CITY OF ALBUQUERQUE

Re: Chipotle Mexican Grill
1000 Juan Tabo Blvd. NE, Suite TBD
30-Day Temporary Certificate of Occupancy
Transportation Development Final Inspection
Engineer's Stamp dated 10-11-21 (J22-D012D)
Certification dated 3-22-22

Traffic Circulation Layout Plan

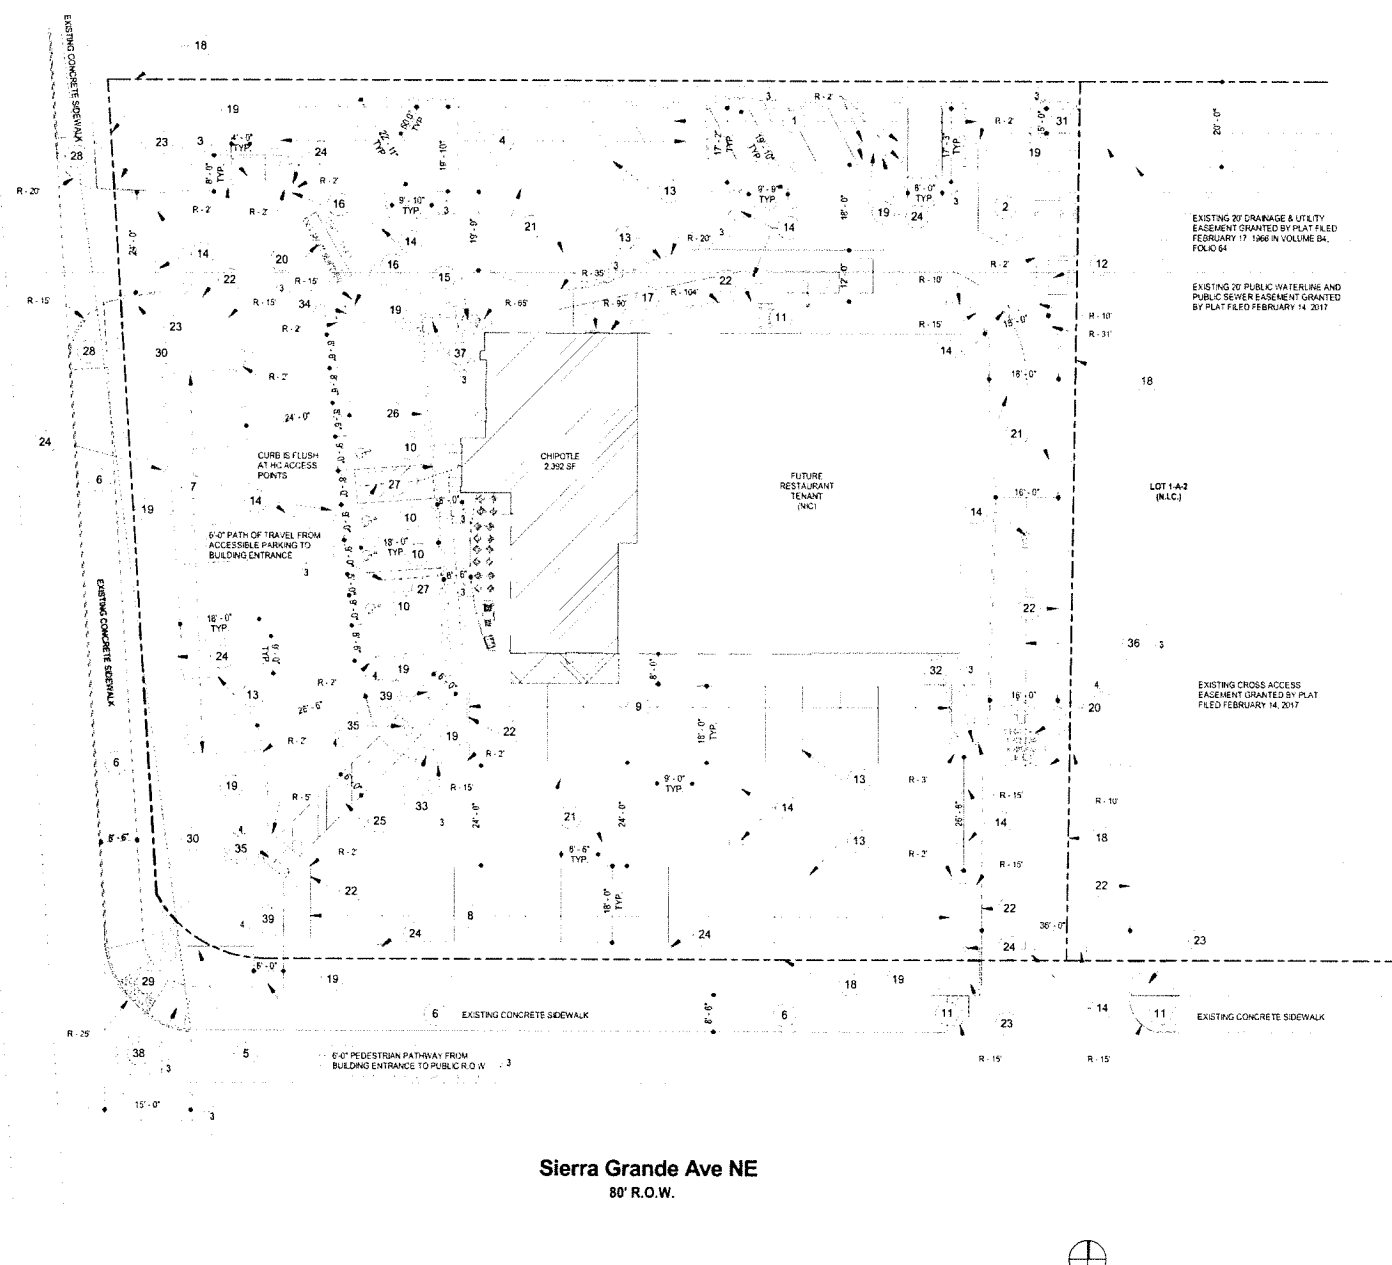
CURRENT SLOPE PERCENTAGES	1	2	3	4	5	6
	1.2%	4.4%	7.6%	2.0%	8.2%	1.5%
MUST BE UNDER	2.0%	5.0%	5.0%	2.0%	8.3%	2.0%

Traffic Circulation
Layout Plan

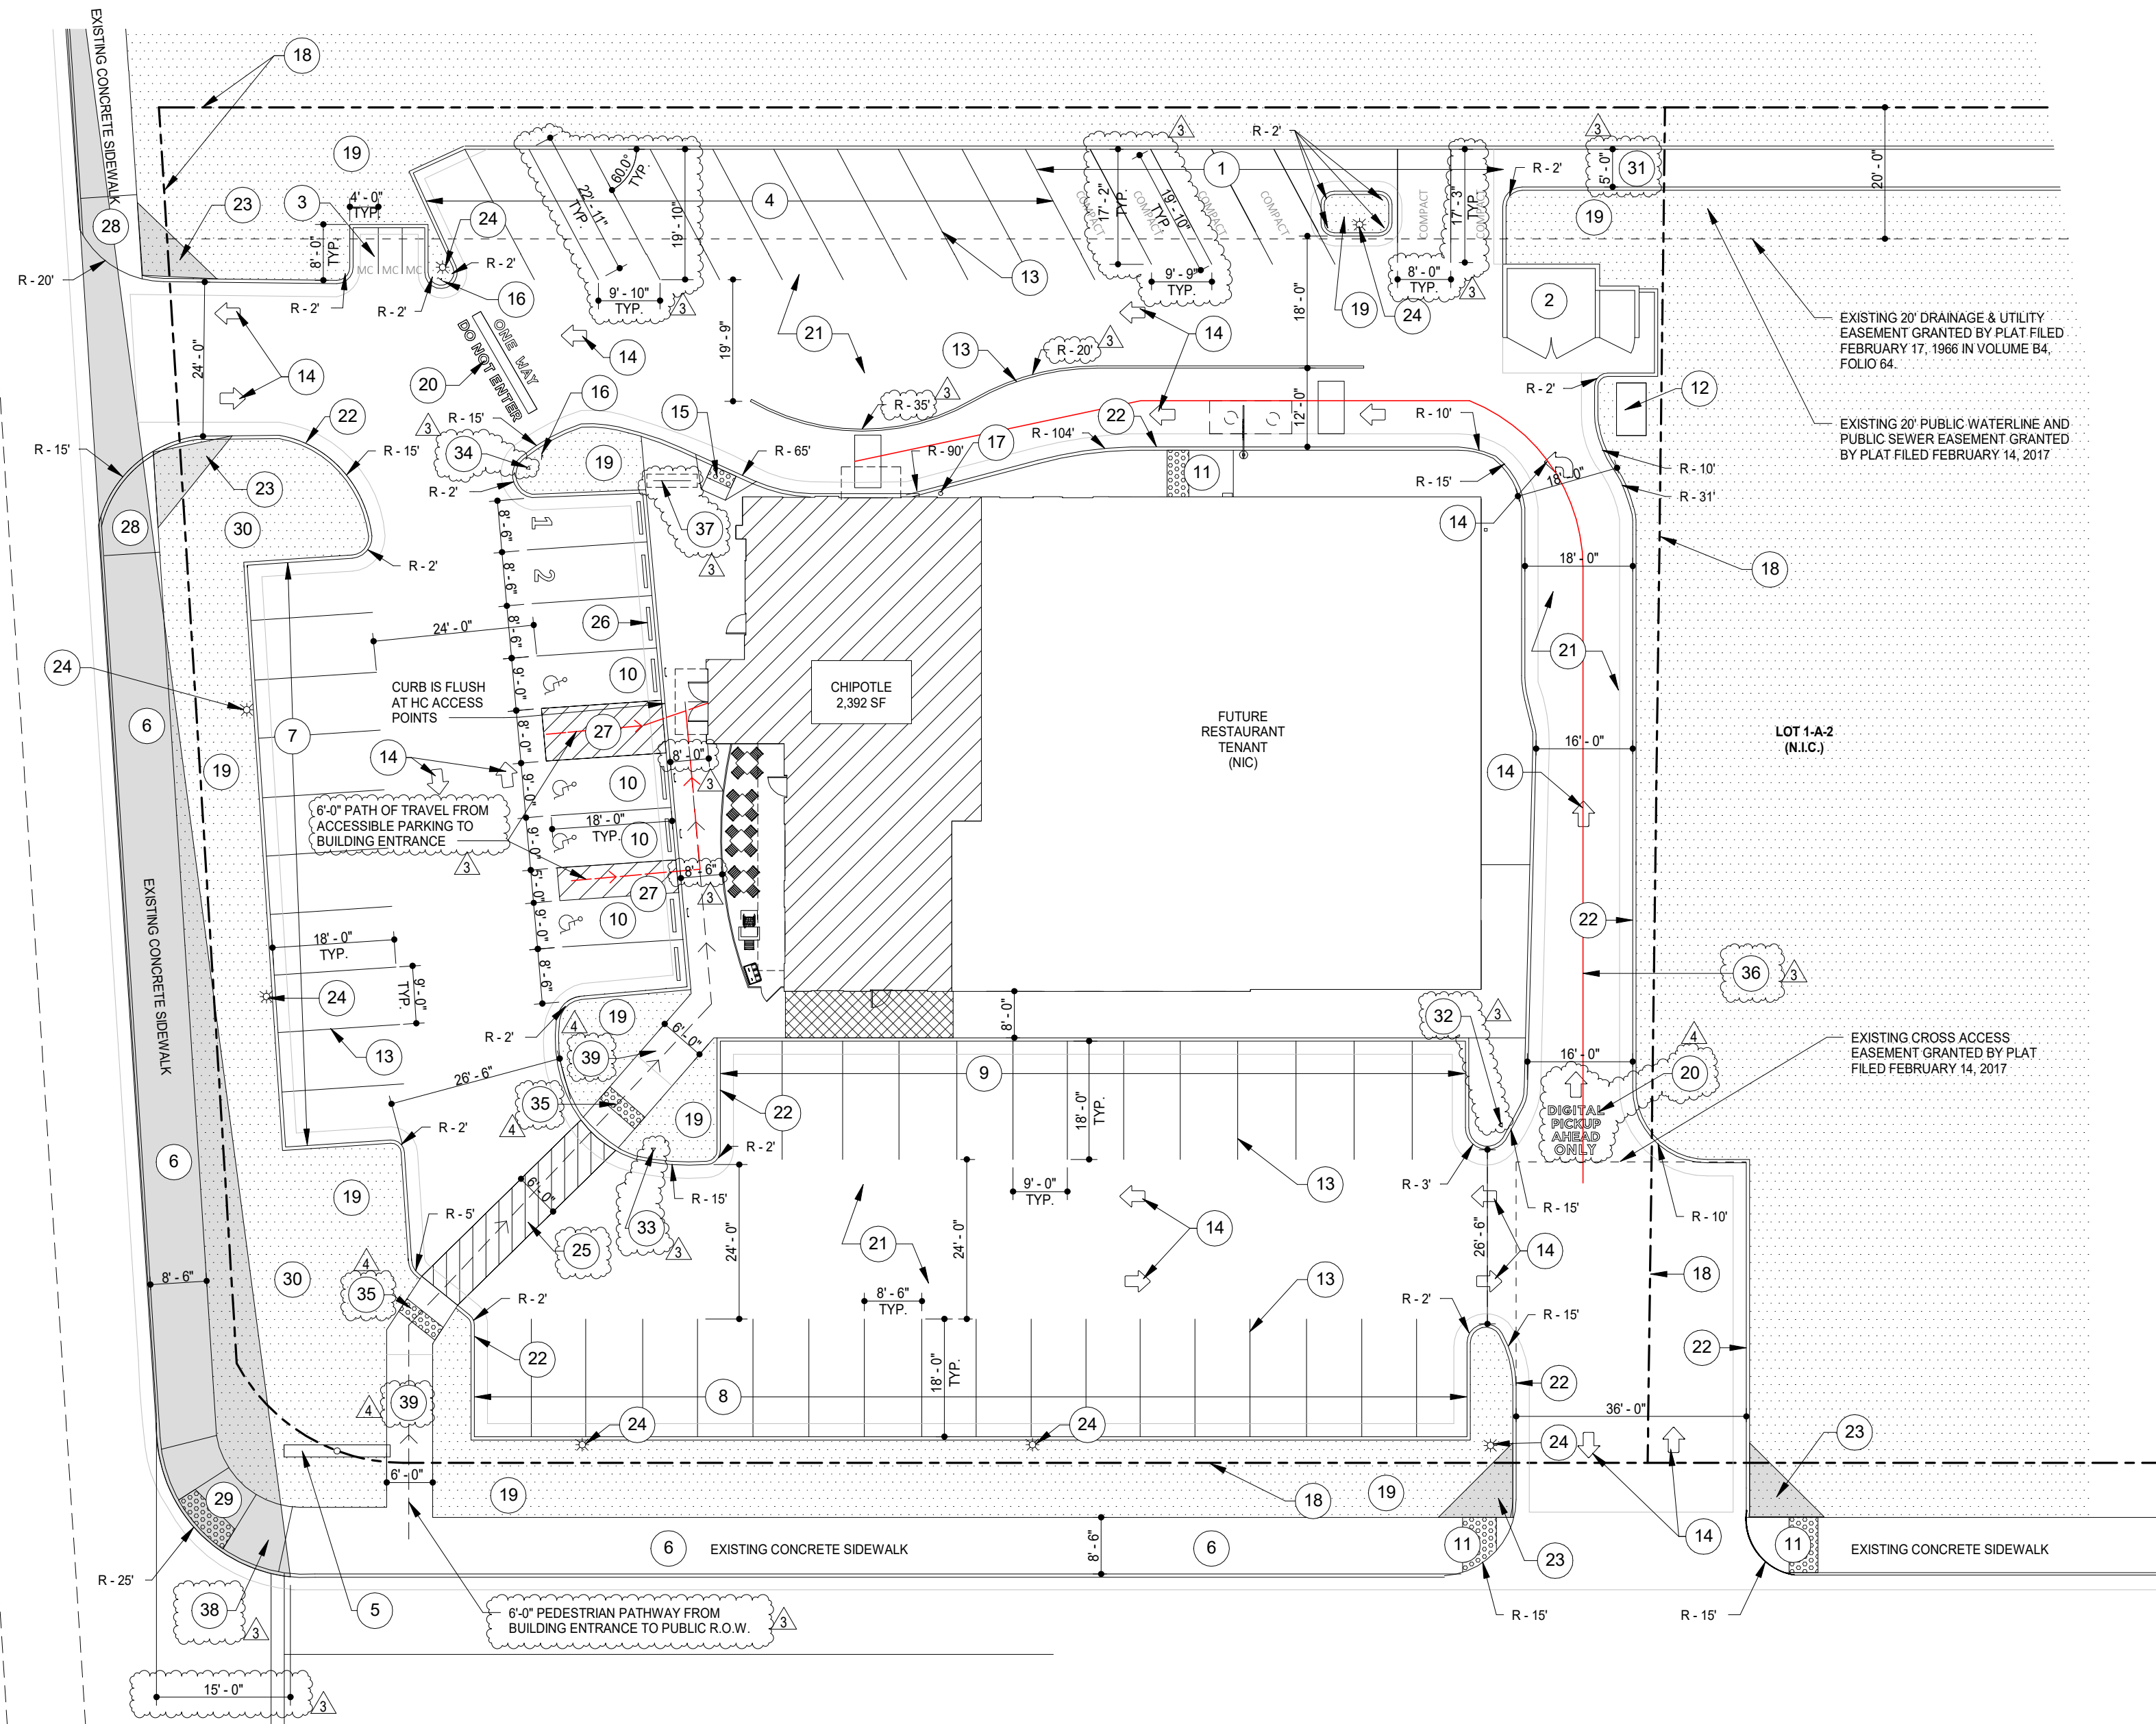
1. Key note 39 (Pedestrian path way):
 - Please fill the gap between the land scape and the path way.
 - Remove the plastic cover from the Truncated Domes.
 - The slope of the segment adjacent to the sidewalk is 5.2% to 6.2%. Please red mark the approved site plan.
2. Key note 32: per site visit, the digital pickup sign is located at the eastside of the begging of the drive-thru. Please red mark the site plan for the sign relocation.
